# Arborist Assessment Report

Tamworth Regional Council

PROJECT DSJN1429

Site Address: King George Ave Tamworth

(Fig 6) Option 1: Between existing power poles and trees: Involves the construction of a concrete path approximately 500mm offset from the line of the power poles, leaving 2-3m offset to the tree line.

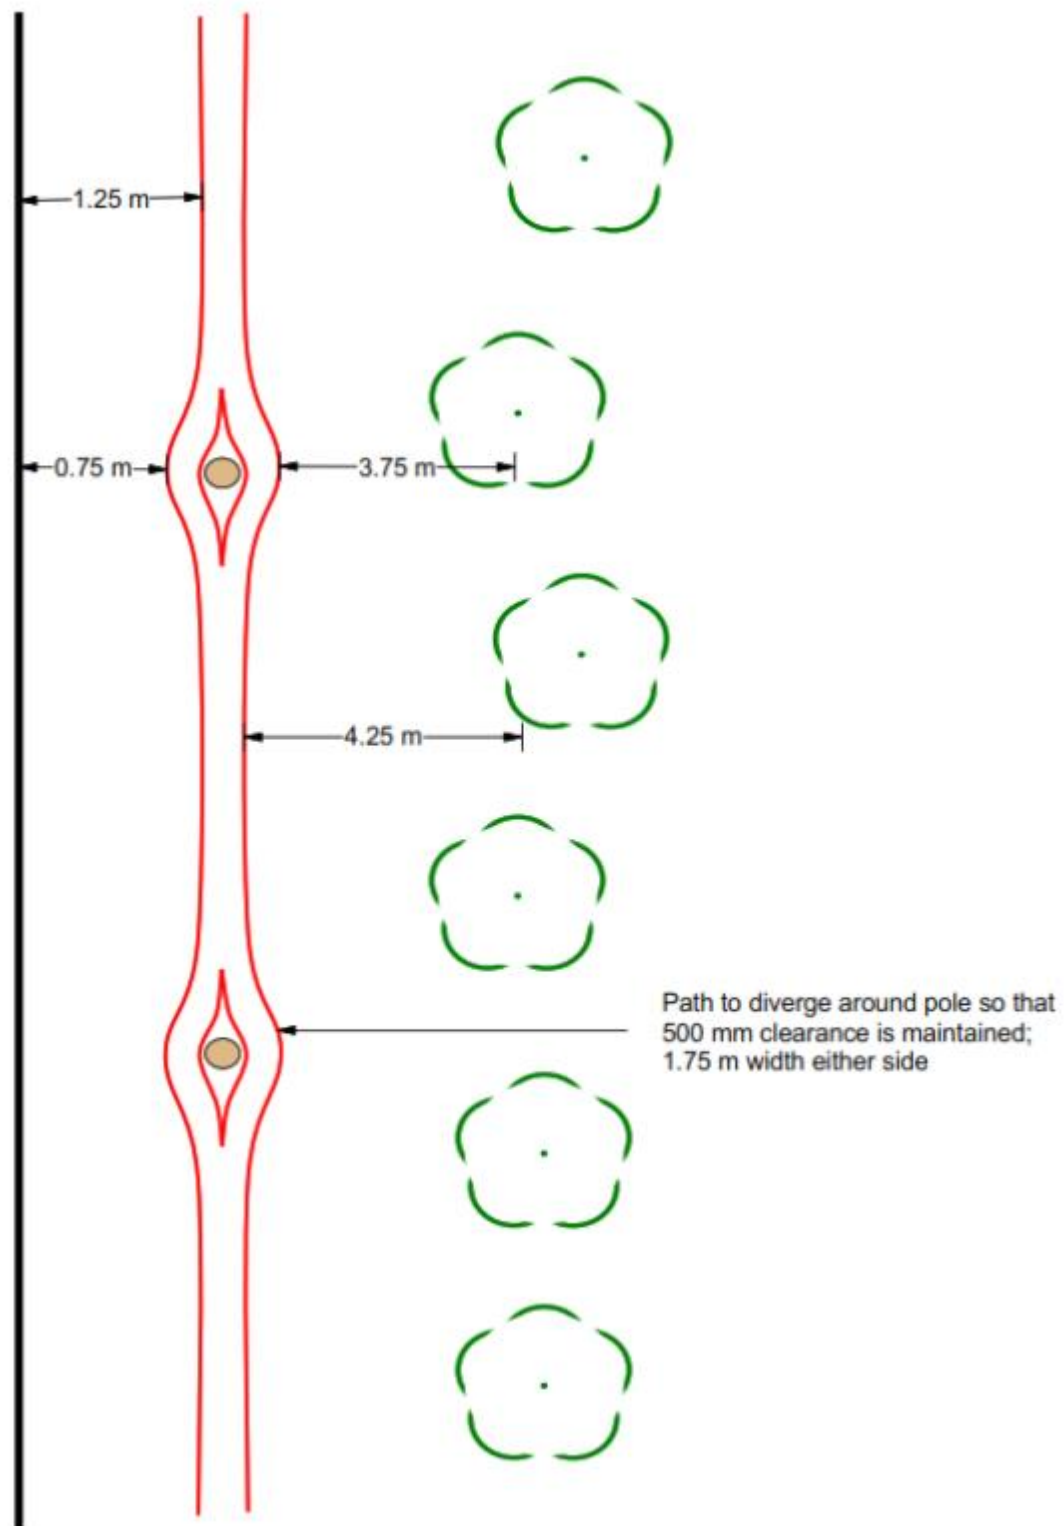
**OPTION 1: Between existing power poles and trees:** *Involves the construction of a concrete path approximately 500mm offset from the line of the power poles, leaving 2-3m offset to the tree line. (Fig 6 for basic concept plan)*

Construction of a concrete path within 3 m of the centre alignment of the 48 trees will encroach into the SRZ of 30 mature trees or (62.5% of the trees will have Structural Roots impacted) further the calculation of incursion greater than 10% into the TPZ of 44 trees or (91.6 % of the trees will be impacted Table 5 below).

Locating the path directly under the canopy, is encouraging people to be under these trees, given the current tree health and structure, the potential for tree sectional failure is a considerable concern. Sectional failure is within the canopy drop zone. (See Photo G & F) This tree is located on the northern side of the avenue but clear example of a failure.

Operations of heavy equipment under the canopy of the trees within the TPZ of 3m distance from the centre of the tree has the potential to cause damage to lower canopy branches by mechanical impact, compaction to roots system will occur by track or wheeled equipment inside the TPZ and structural root damage by excavations will be the result.

- Option :1 is not acceptable design.
- Option 2 is acceptable with is the least impact on the trees.
- Option 3 is acceptable but require minor changes to design.
